REVISION HISTORY

Rev.2A

QCOM QBTM300 Rev.2A

- Customized Form Factor Bluetooth Module
- CSR BC03-ROM Chipset
- Antenna Attached
- PN# 59-6175-2A

QCOM		
Title	QBTM300	
Size	Document Number	Rev
C	BC03-ROM	2A
Date:	Monday, January 10, 2005	Sheet 2 of 2

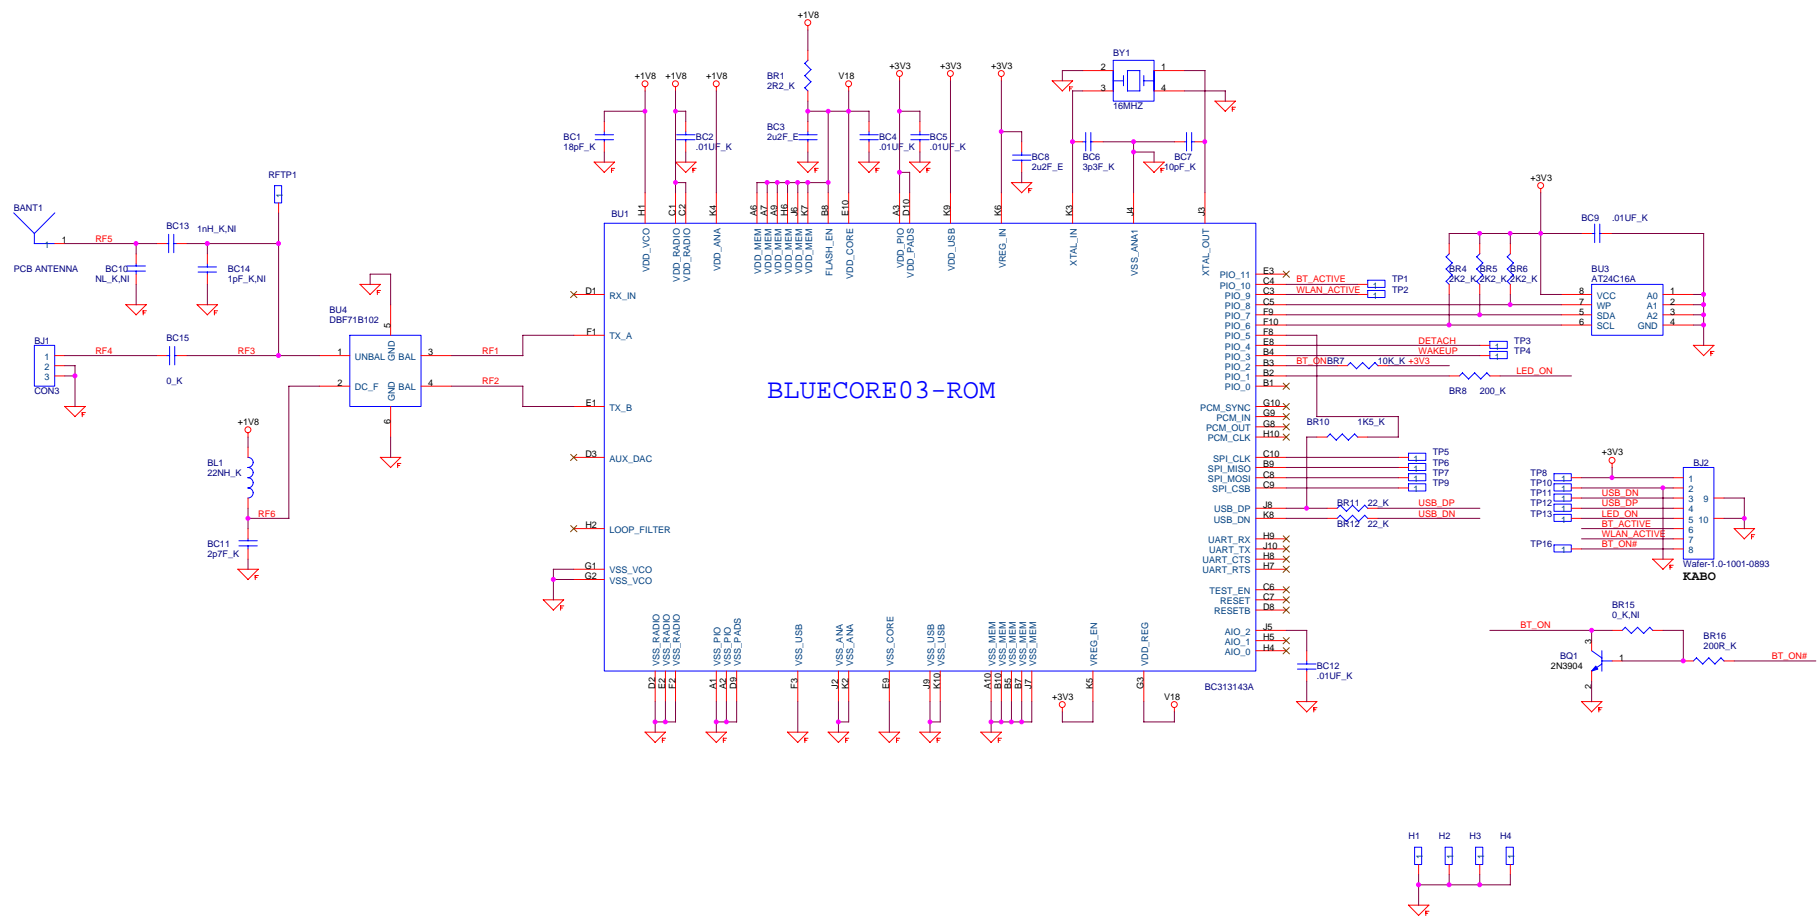
1. Change BU3 Power to +3V3.
2. Del BR13, BR14.
3. Change BC13 to 1nH_K,NI.
4. Change BC14 to 1pF_K,NI.
5. Change BC15 to 0_K.
6. Change RF Trace to 10.5mil width.
7. Power plane re-layout.
8. Increase board width for shielded cover.
